CFM56-7B S/B 80-0016 – Introduction of New V-Band Clamp VIN 31428-6600 (P/N 2635M04P01)

CFM56-7B S/B 80-0016: Eaton P/N 31428-6600

- This Service Bulletin introduces a new V-band clamp VIN 31428-6600 (P/N 2635M04P01)

7B_80-0016R0 Coupling retrofit Eaton p/n 31428-6600

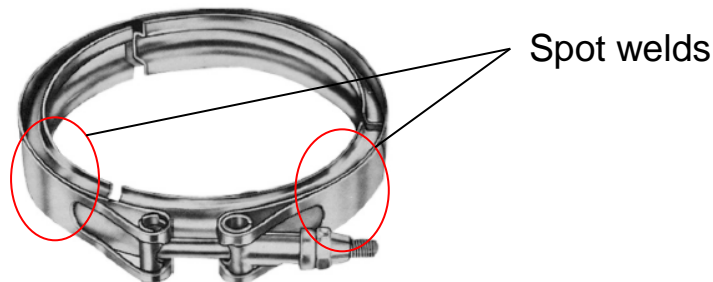
- The welded sheet metal clamp is known to crack in the weld and fails in High Cycle Fatigue (HCF). Overtorque during installation of the Sheet metal clamp is known to increase the likelihood of cracking

Sheetmetal coupling

- Contains welds
- Manufactured from stainless steel sheet
- Installation torque = 49-55 lb-in
 - Highly sensitive to overtorque

Machined coupling

- No welds - fully machined
- Manufactured from heat resistant alloys
 - A-286 retainers
 - Inconel 718 & A-286 hardware
- Increased margin compared to sheetmetal coupling
- Installation torque = 115-125 in-lb
 - Torque marked on part
 - Torque common to similar machined couplings on the engine

No spot welds
